**TOWN OF BAY HARBOR ISLANDS
MORRIS N. BROAD COMMUNITY CENTER**

**DEVELOPMENT & REVIEW COMMITTEE MEETING
THURSDAY, FEBRUARY 8, 2024**

**TOWN OF BAY HARBOR ISLANDS
COMMUNITY DEVELOPMENT
MEMORANDUM**

Subject: Site Development Plan Application – 2024 Revisions
1177 Kane Concourse Mixed Use Development
Increase DU from 54 to 66 / Revise MFR Façades (N&E) / Revise Rec. Deck
Bay Harbor Islands Acct. No. SPR24-000004
MMPA Acct. No. 01-0702-1063D

2nd FLOOR RESIDENTIAL COURTYARD
PROPOSED CHANGE

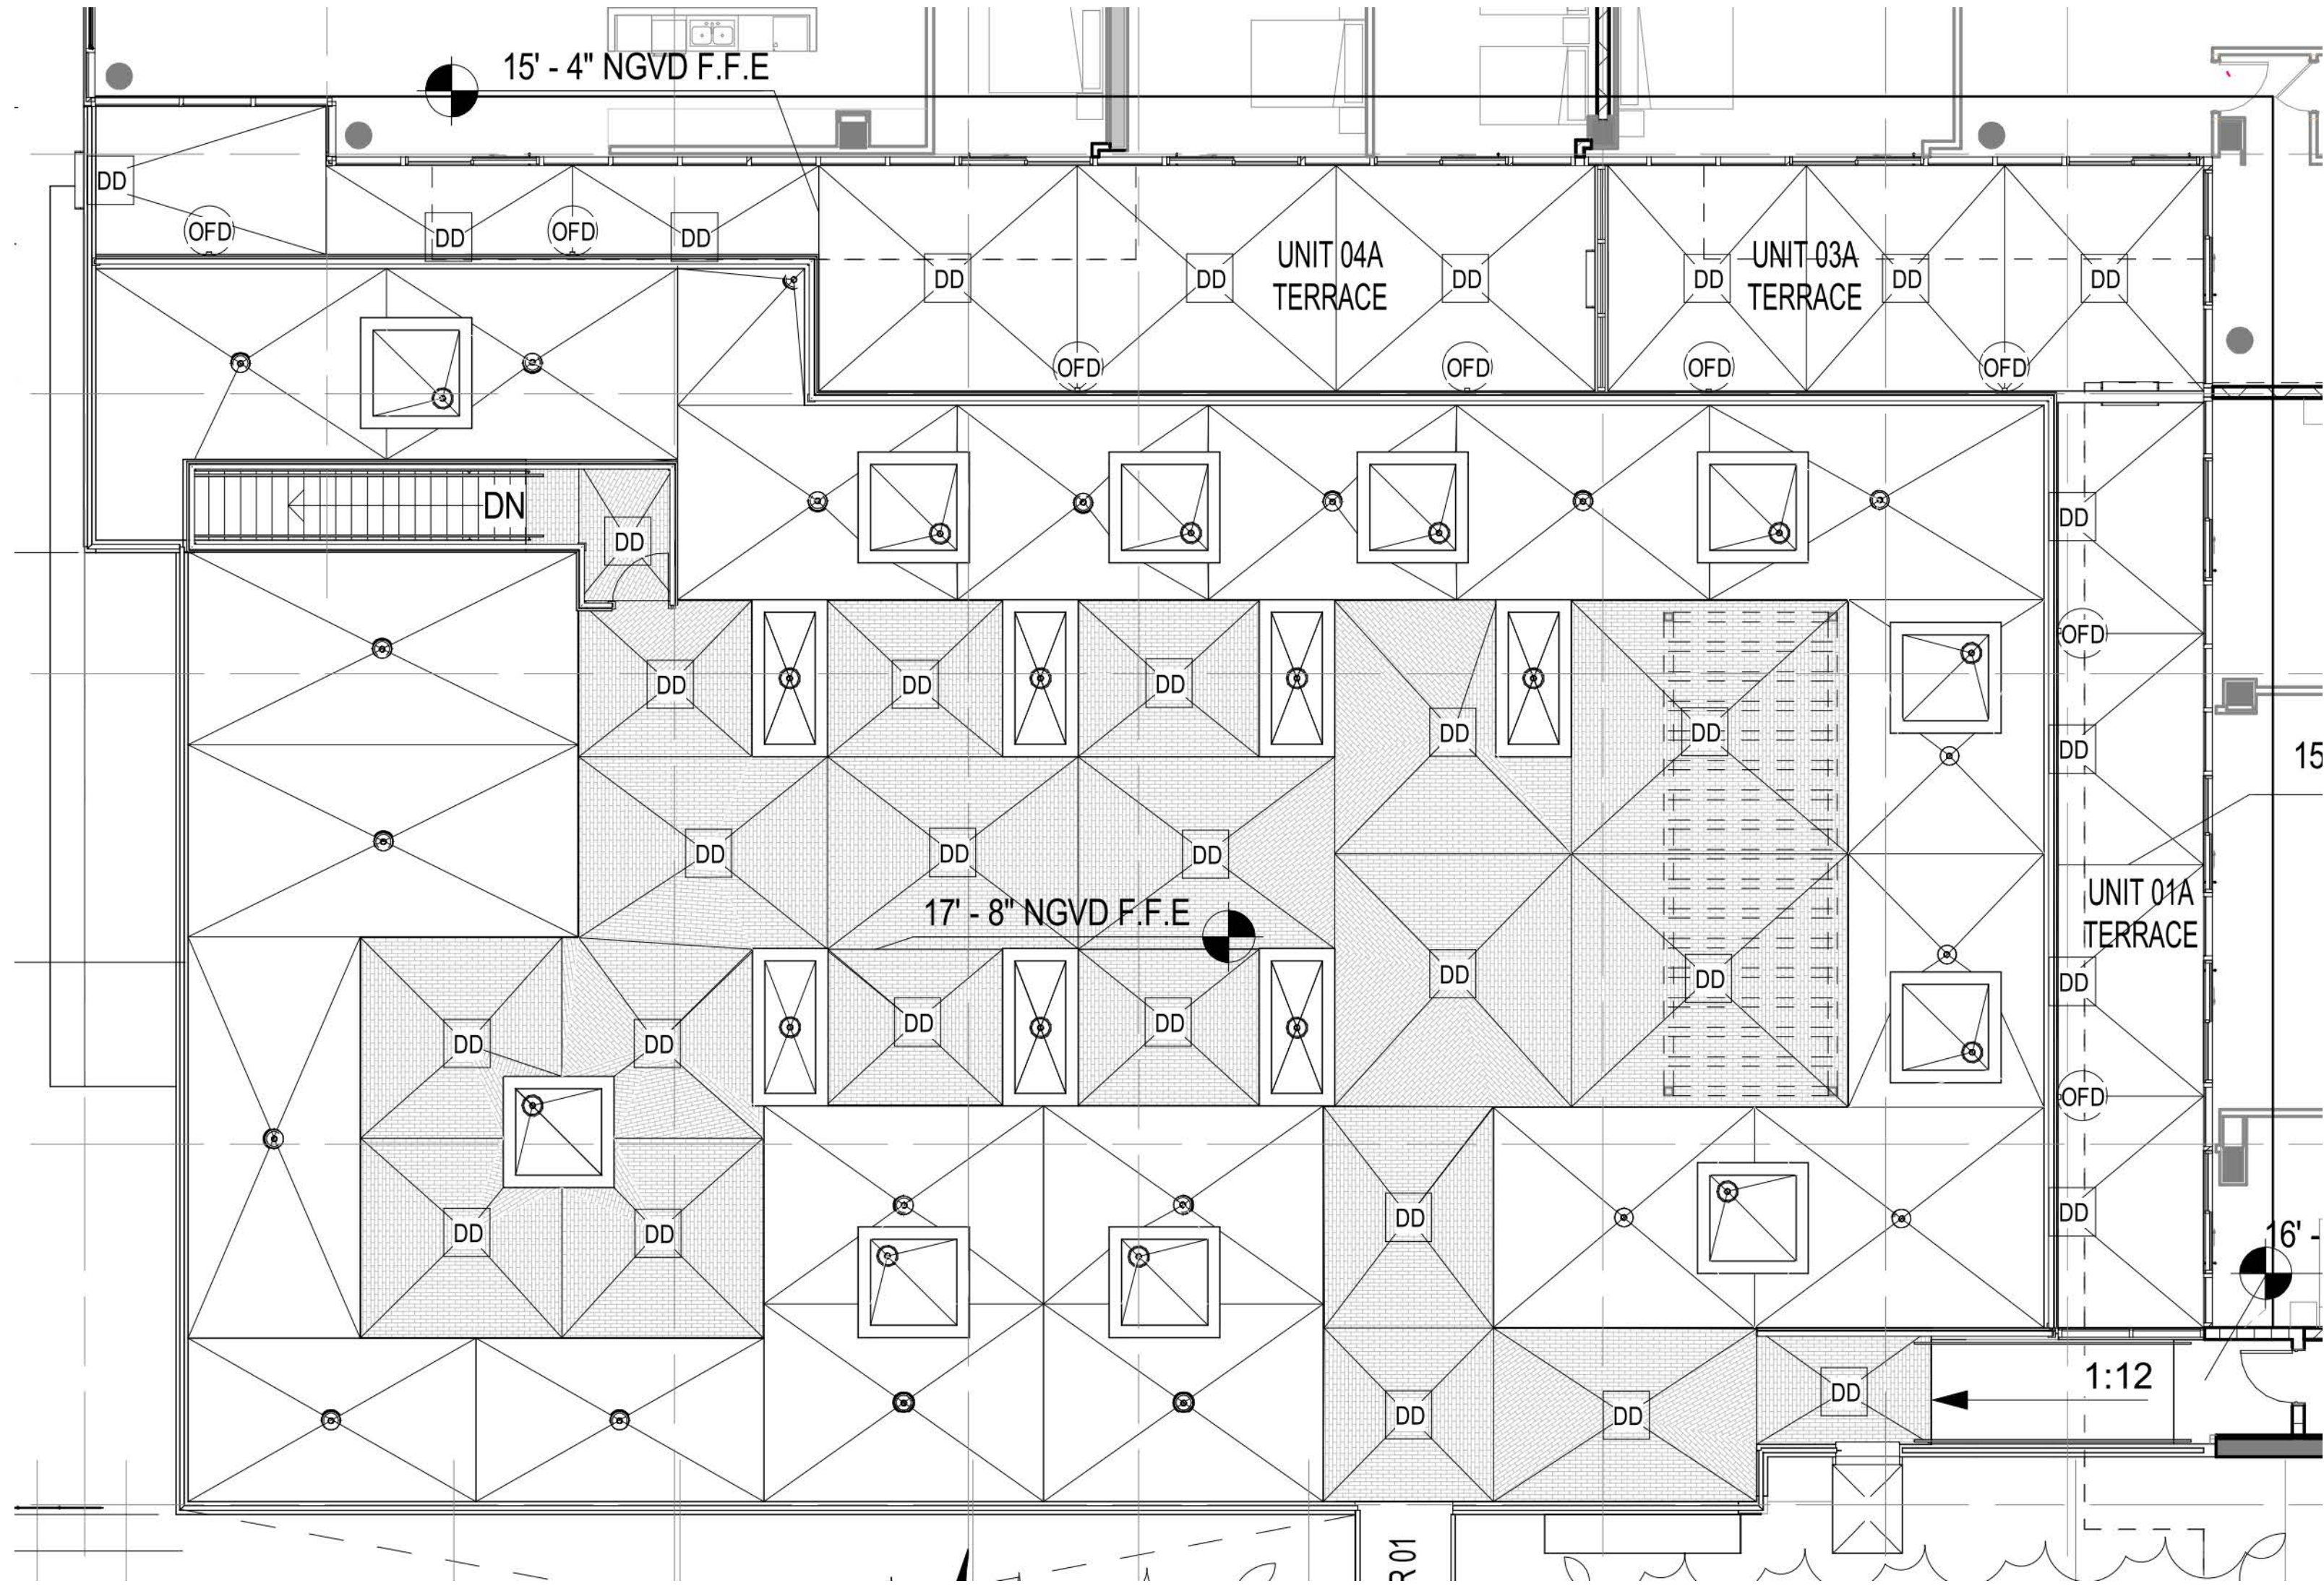
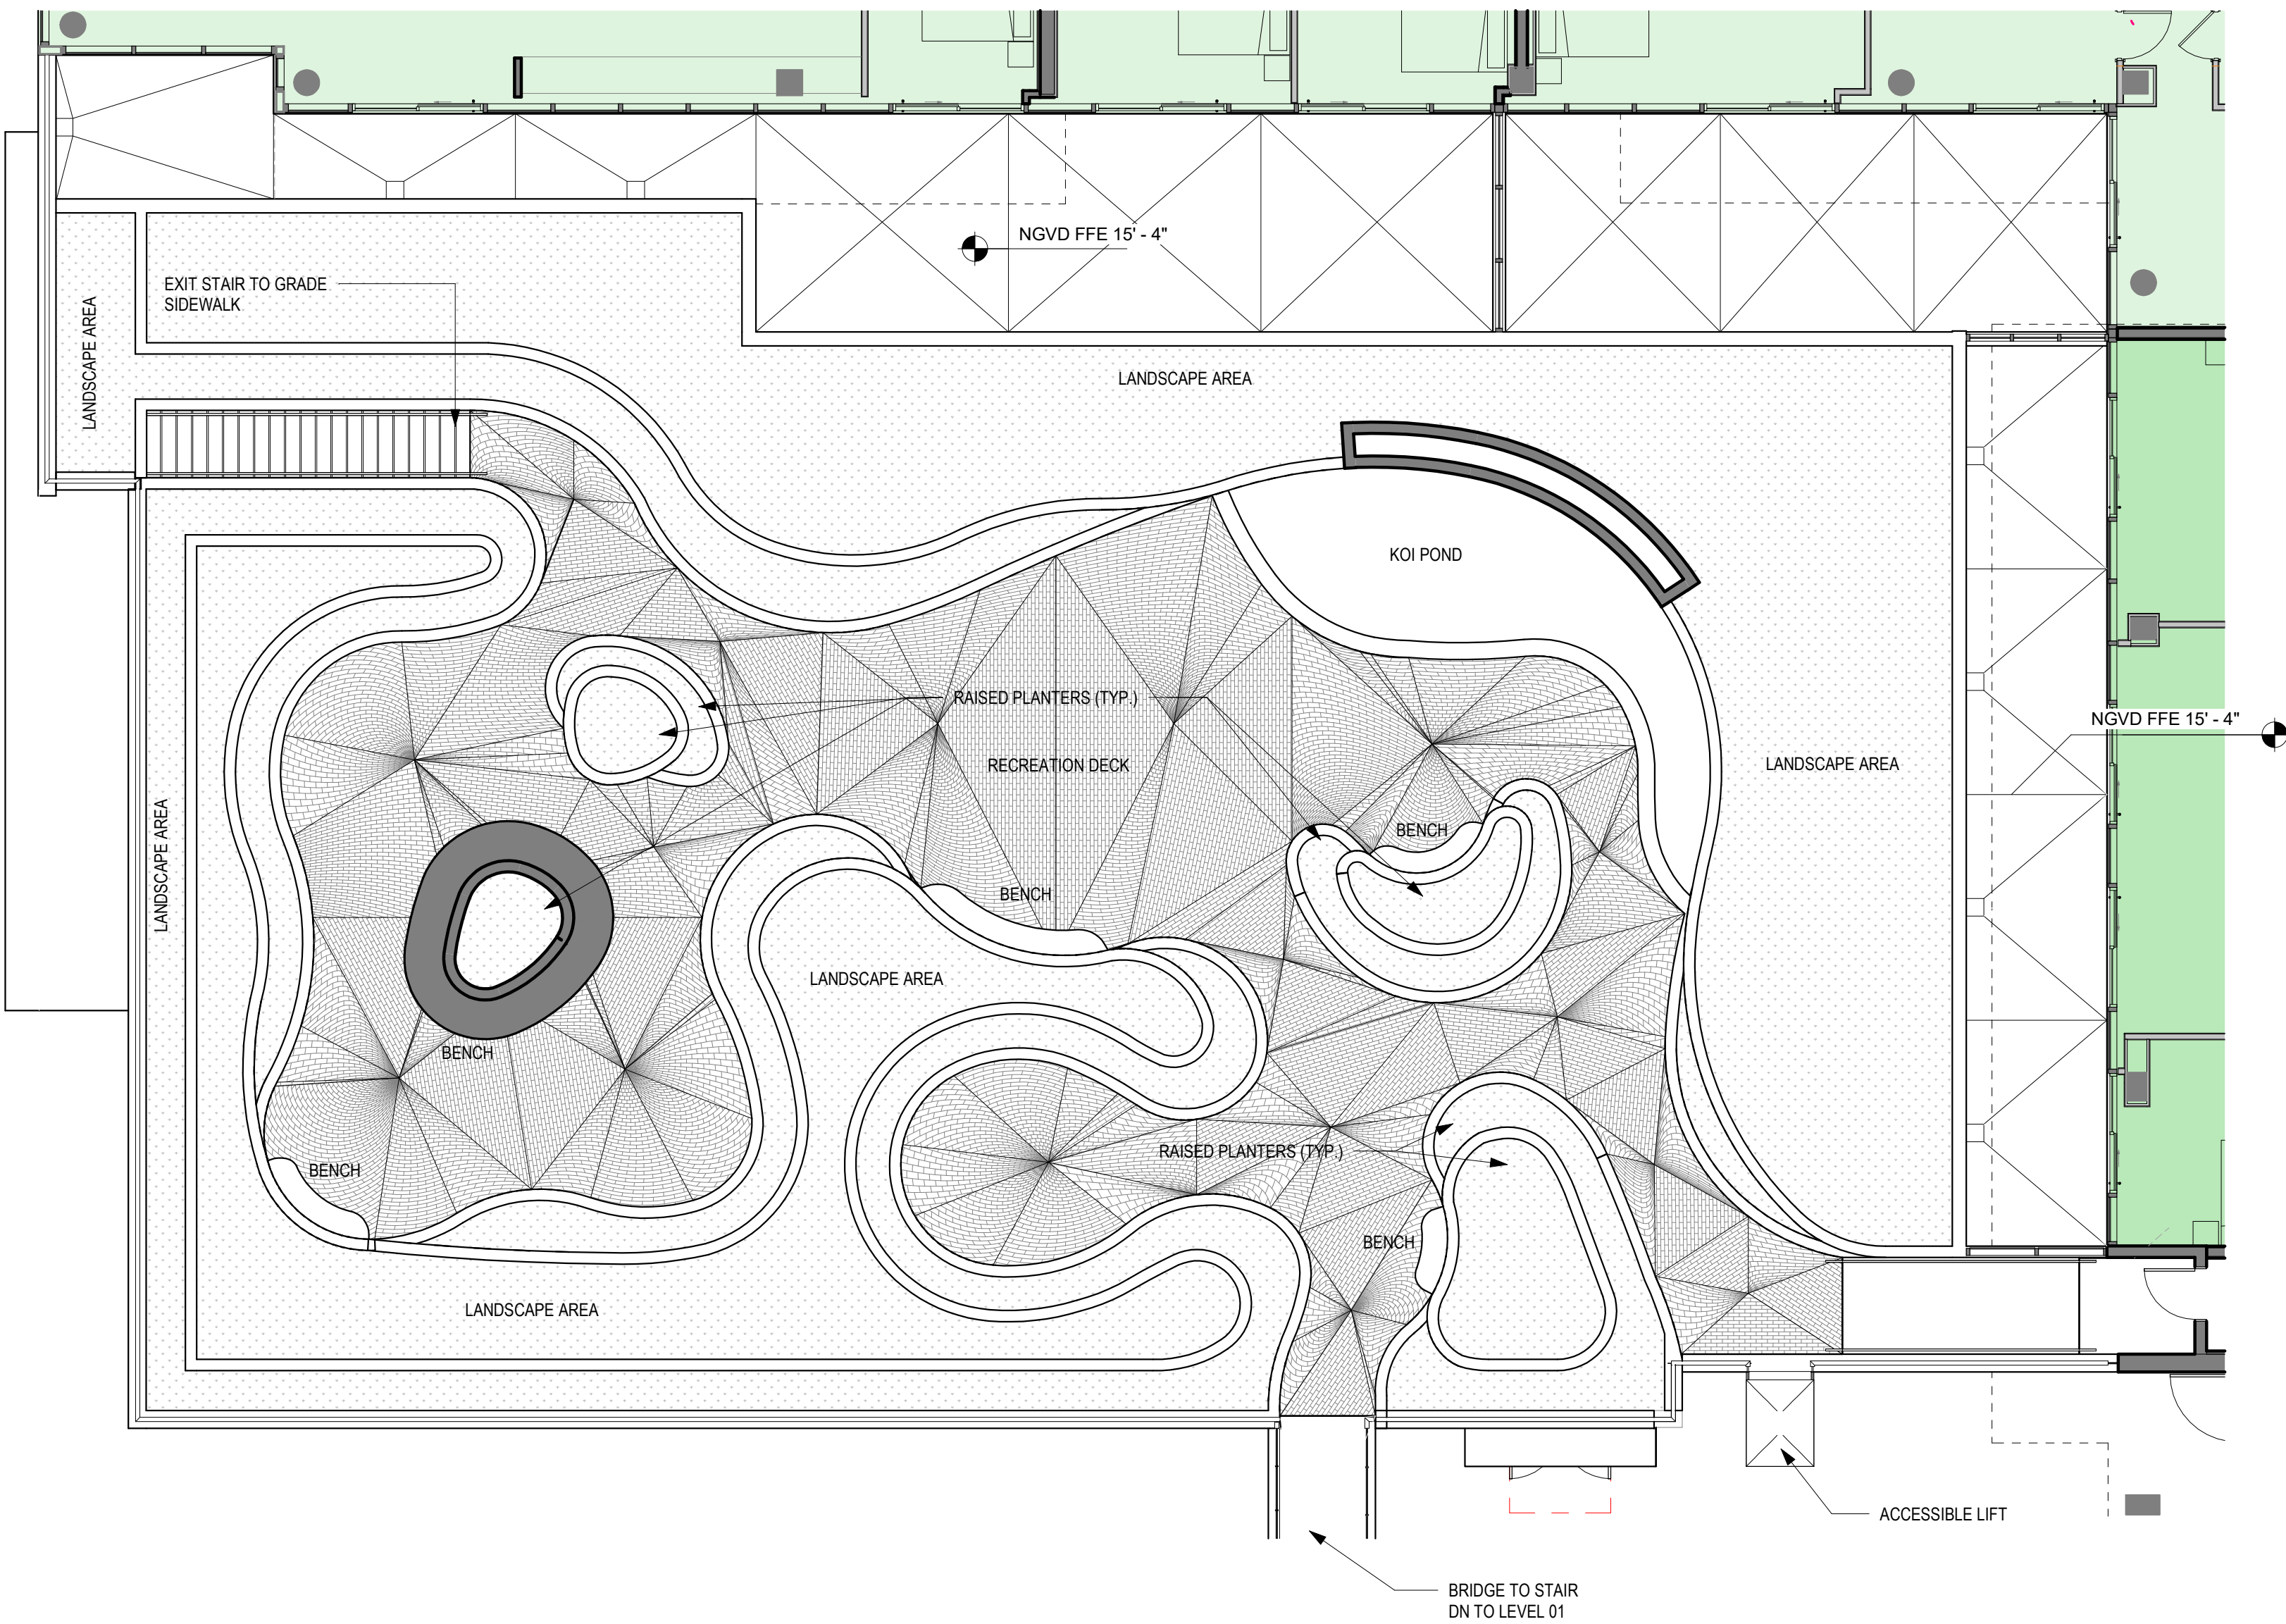
- PLANTERS AREAS WERE REARRANGED AND THE PLANTER SHAPE WAS MODIFY TO PROVIDE A TWO TIER PLANTER.
- A NEW WATER FEATURE WAS ADDED ON THE NORTH EAST SIDE OF THE DECK.
- THE PLAZA USE AND OCCUPANCY CAPACITY WILL REMAIN THE SAME AS THE ORIGINAL DESIGN.
- PLAZA WILL REMAIN FOR PUBLIC USE.
